Access Compliance Report

Public Rights-of-Way (Curb Ramps)

Intersection ID: 50611	Main Street: COTTON_GUM_RD	Cross Street: DOWNY_BIRCH_RD	Location: SW
ADA ID: C5B8BF2967BC	Ramp Type: BlendTrans1	Initial Pass/Fail: Fail	Overall Compliance: No
Severity Score: 25			
Codes/Mitigation Info/Possible Solution		Field Measurements/Component Compliance

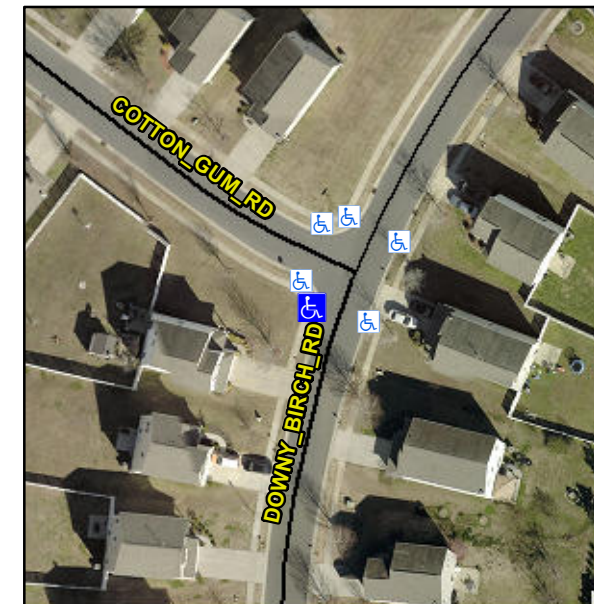
Not Found, R304.5.3

Compliance	Description	Data	Compliance	Description	Data
N/A	Ramp Length (in)	48.0	Yes	BlendTrans Slope (%)	3.7
Yes	Ramp Width (in)	48.0	No	BlendTrans XSlope (%)	7.3
N/A	Flare Type LT	N/A	N/A	Flare Type RT	N/A
N/A	Flare Slope LT (%)	N/A	N/A	Flare Slope RT (%)	N/A
N/A	Flare Traversable LT?	N/A	N/A	Flare Traversable RT?	N/A
N/A	Landing Length (in)	N/A	N/A	DWS Provided?	N/A
N/A	Landing Width (in)	N/A	N/A	DWS Contrast?	N/A
N/A	Landing Slope (%)	N/A	N/A	DWS Length (in)	N/A
N/A	Landing X Slope (%)	N/A	N/A	DWS Full Width?	N/A
N/A	Landing Curb? (Y/N)	N/A	N/A	DWS Offset (in)	N/A
N/A	Shared Landing?	N/A			
N/A	Gutter Ponding?	N/A	N/A	Gutter Slope (%)	N/A
N/A	Gutter Lip Ht (in)	N/A	N/A	Gutter X Slope (%)	N/A
N/A	Painted X Walk1?	No	N/A	Painted X Walk2?	N/A
	X Walk 1 Direction	To E		X Walk 2 Direction	N/A
	X Walk 1 Width (in)	N/A		X Walk 2 Width (in)	N/A
	X Walk 1 Slope (%)	4.4		X Walk 2 Slope (%)	N/A
	X Walk 1 X Slope (%)	4.5		X Walk 2 X Slope (%)	N/A

N/A	Ramp inside XWalk1?	N/A	N/A	Ramp inside XWalk2?	N/A
	Road Slope (%)	4.5		Clear Space?	N/A
	Road X Slope (%)	4.4	N/A	Clear Space to XWalk (in)	N/A
N/A	Any Obstructions?	N/A	N/A	Storm Grate/Utility Hazard?	N/A
	Obstruction Type			Storm Grate/Utility Type	
		N/A			N/A
			Yes	Surface Condition? (G/P)	Good
			No	Curb Slope (%)	10.4

Remove & Replace Curb Ramp With Two New Directional Ramps or Equivalent.
